**New York City Department of Transportation  
Division of Bridges  
Bureau of Specialty Engineering and Construction  
Design Build/Emergency Contracts Unit**

**DESIGN, CONSTRUCTION AND CONSTRUCTION SUPPORT SERVICES  
FOR THE FOR THE REHABILITATION OF  
THE ST. GEORGE STATEN ISLAND FERRY TERMINAL RAMPS  
BOROUGH OF STATEN ISLAND  
CONTRACT No. HBR1217  
P.I.N. 84106SIBR096**

**Addendum # 5**

**January 7, 2008**

PIGEON DETERRENT SYSTEM  
LIMITS OF WORK

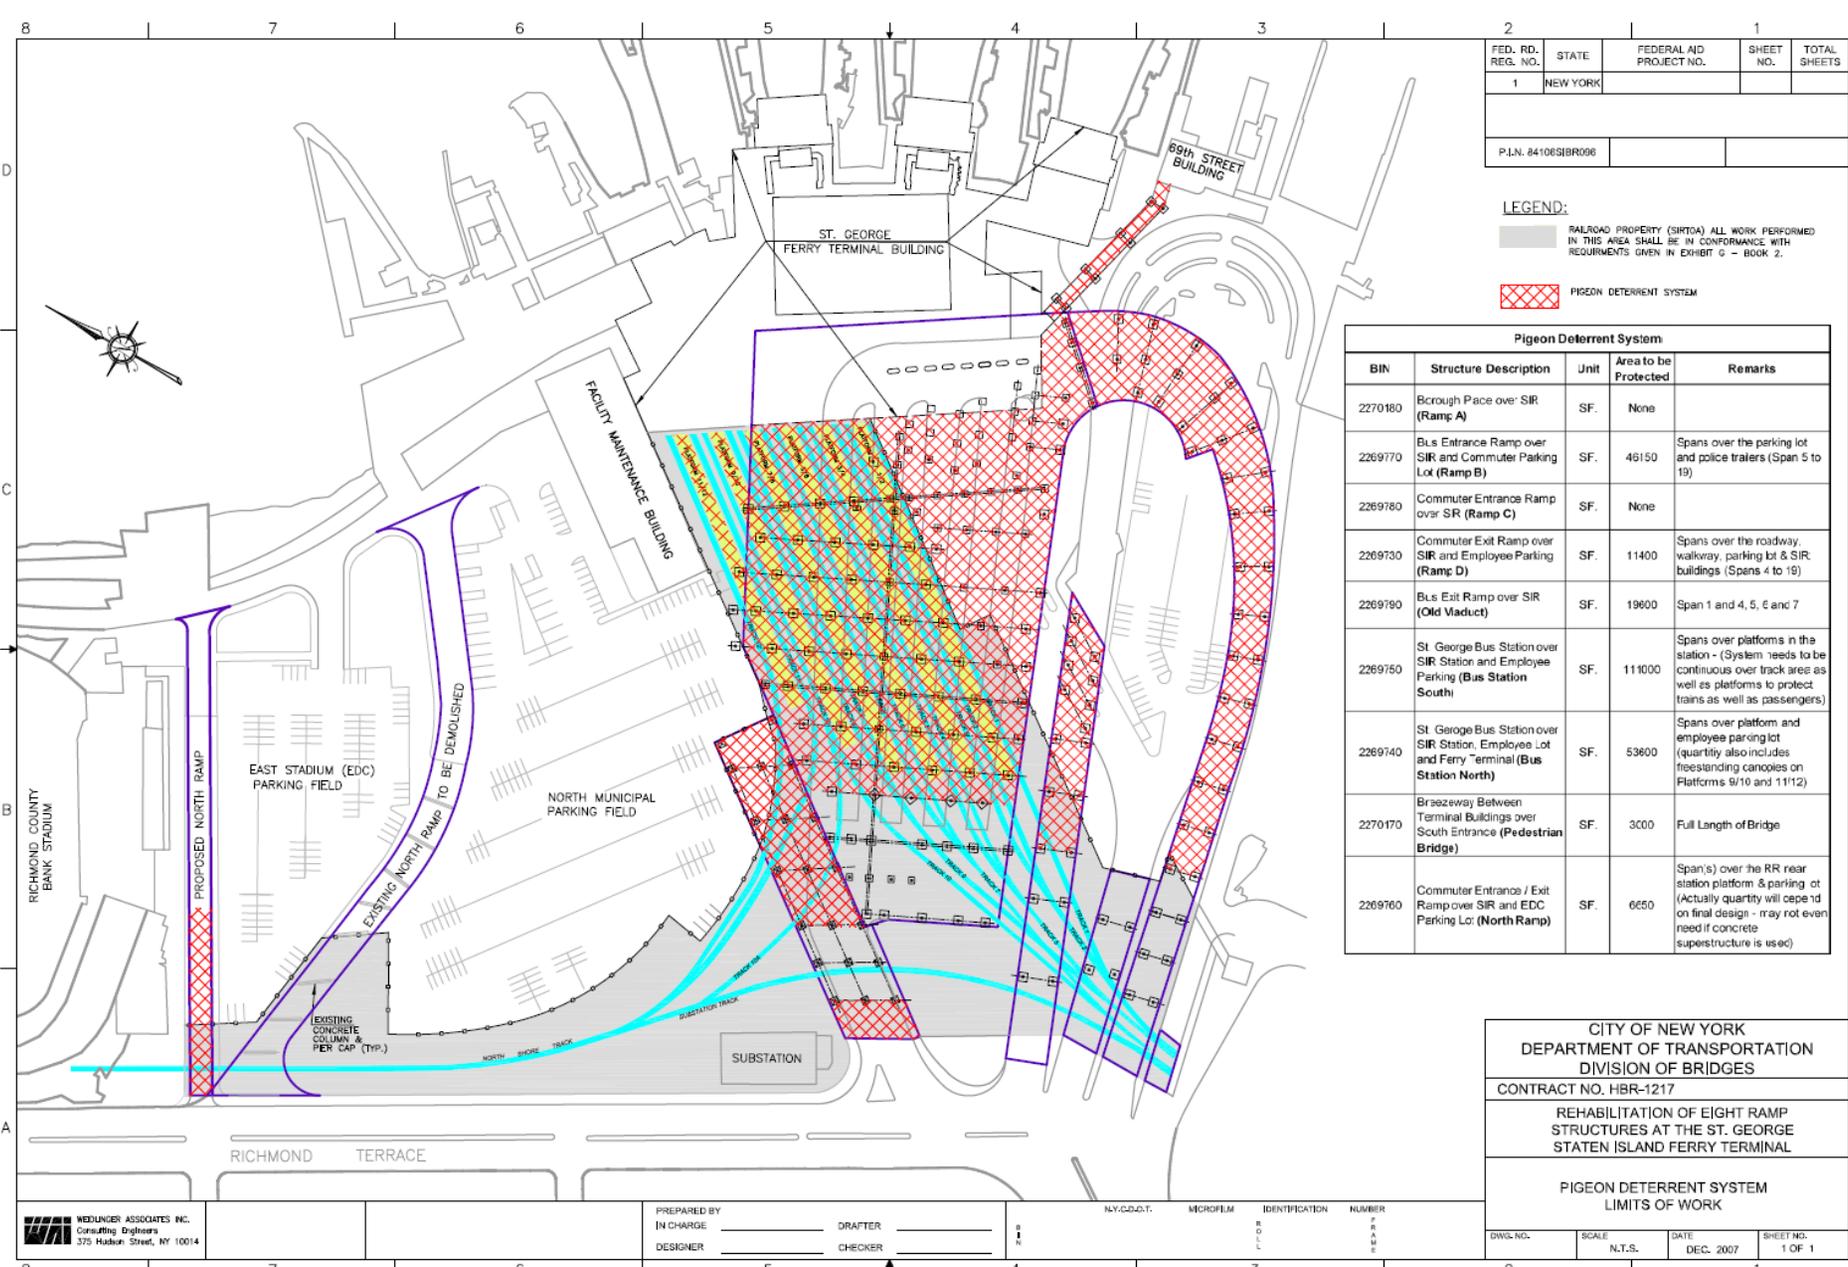
REFER TO: PIGEON DETERRENT SYSTEM – LIMITS OF WORK drawing provided in Addendum # 4

**REPLACE: PIGEON DETERRENT SYSTEM – LIMITS OF WORK drawing provided in Addendum # 4 in its entirety with attached Page 1618R, PIGEON DETERRENT SYSTEM – LIMITS OF WORK**

REFER TO: Book 2: Volume 2, EXHIBIT E – SCOPE OF WORK, Preliminary Drawings, Page 1618

**REPLACE: Page 1618 in its entirety with Page 1618R, PIGEON DETERRENT SYSTEM – LIMITS OF WORK**

Pigeon Deterrent System				
BIN	Structure Description	Unit	Area to be Protected	Remarks
2270180	Borough Place over SIR (Ramp A)	SF.	None	
2269770	Bus Entrance Ramp over SIR and Commuter Parking Lot (Ramp B)	SF.	46150	Spans over the parking lot and police trailers (Span 5 to 19)
2269780	Commuter Entrance Ramp over SR (Ramp C)	SF.	None	
2269730	Commuter Exit Ramp over SIR and Employee Parking (Ramp D)	SF.	11400	Spans over the roadway, walkway, parking lot & SIR buildings (Spans 4 to 19)
2269790	Bus Exit Ramp over SIR (Old Viaduct)	SF.	19600	Span 1 and 4, 5, 6 and 7
2269750	St. George Bus Station over SIR Station and Employee Parking (Bus Station South)	SF.	111000	Spans over platforms in the station - (System needs to be continuous over track area as well as platforms to protect trains as well as passengers)
2269740	St. George Bus Station over SIR Station, Employee Lot and Ferry Terminal (Bus Station North)	SF.	53600	Spans over platform and employee parking lot (quantity also includes freestanding canopies on Platforms 9/10 and 11/12)

2270170	Breezeway Between Terminal Buildings over South Entrance (Pedestrian Bridge)	SF.	3000	Full Length of Bridge
2269760	Commuter Entrance / Exit Ramp over SIR and EDC Parking Lot (North Ramp)	SF.	6650	Span(s) over the RR rear station platform & parking lot (Actually quantity will depend on final design - may not even need if concrete superstructure is used)
